# Access Compliance Report

## Public Rights-of-Way

### (Curb Ramps)

Intersection ID: 10027950	Main Street: HARDING_PL	Cross Street: N/A	Location: E
ADA ID: A9FFE6BB5643	Ramp Type: Directional1	Initial Pass/Fail: Fail	Overall Compliance: No
		Severity Score: 25

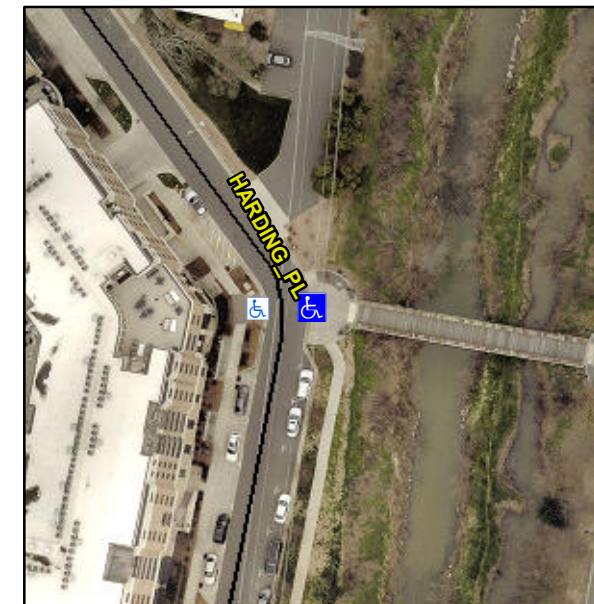
**R304.2.2, R304.5.3**

Compliance	Description	Data	Compliance	Description	Data
N/A	Ramp Length (in)	60.0	N/A	Grade Break?	N/A
Yes	Ramp Width (in)	48.0	N/A	Grade Break Slope (%)	0.0
No	Ramp Slope (%)	8.5	N/A	Grade Break XSlope (%)	0.0
No	Ramp XSlope (%)	5.1			
N/A	Flare Type LT	N/A	N/A	Flare Type RT	N/A
N/A	Flare Slope LT (%)	N/A	N/A	Flare Slope RT (%)	0.0
N/A	Flare Traversable LT?	N/A	N/A	Flare Traversable RT?	N/A
N/A	Landing Length (in)	0.0	N/A	DWS Provided?	N/A
N/A	Landing Width (in)	0.0	N/A	DWS Contrast?	N/A
N/A	Landing Slope (%)	0.0	N/A	DWS Length (in)	N/A
N/A	Landing X Slope (%)	0.0	N/A	DWS Full Width?	N/A
N/A	Landing Curb? (Y/N)	N/A	N/A	DWS Offset LT (in)	N/A
N/A	Shared Landing?	N/A	N/A	DWS Offset RT (in)	N/A
N/A	Gutter Ponding?	0.0	N/A	Gutter Slope (%)	N/A
N/A	Gutter Lip Ht (in)	0.0	N/A	Gutter X Slope (%)	N/A
N/A	Painted X Walk1?	No		Road Slope (%)	11.9
	X Walk 1 Direction	To W		Road X Slope (%)	3.6
	X Walk 1 Width (in)	N/A		Clear Space?	N/A

**Remove & Replace Entire Ramp.**
